ADA Curb Ramp New Construction Inspection Form (Parallel)

NW Timeric

24952.54

NW North Ave

PARALLEL RAMP (PL)

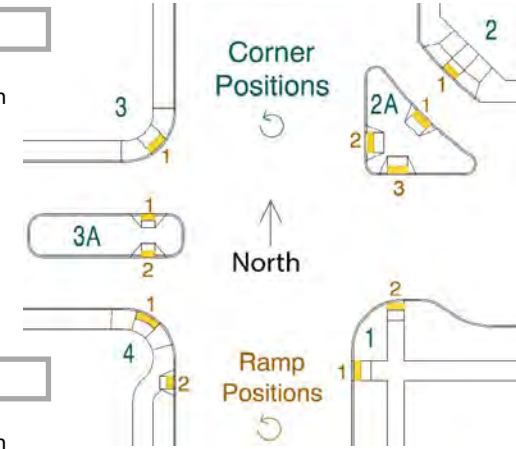
9.7 \leq 2.0% ☐ $>$ 2.0% ☒

4.1 \leq 2.0% ☐ $>$ 2.0% ☒

N Y ☐ N ☒

4.1 \leq |5.0%| ☐ $>$ |5.0%| ☒

N Y ☐ N ☒

7.2 \leq 2.0% ☐ $>$ 2.0% ☒

7.7 \leq 2.0% ☐ $>$ 2.0% ☒

3.9 \geq 4.0' ☐ $<$ 4.0' ☒
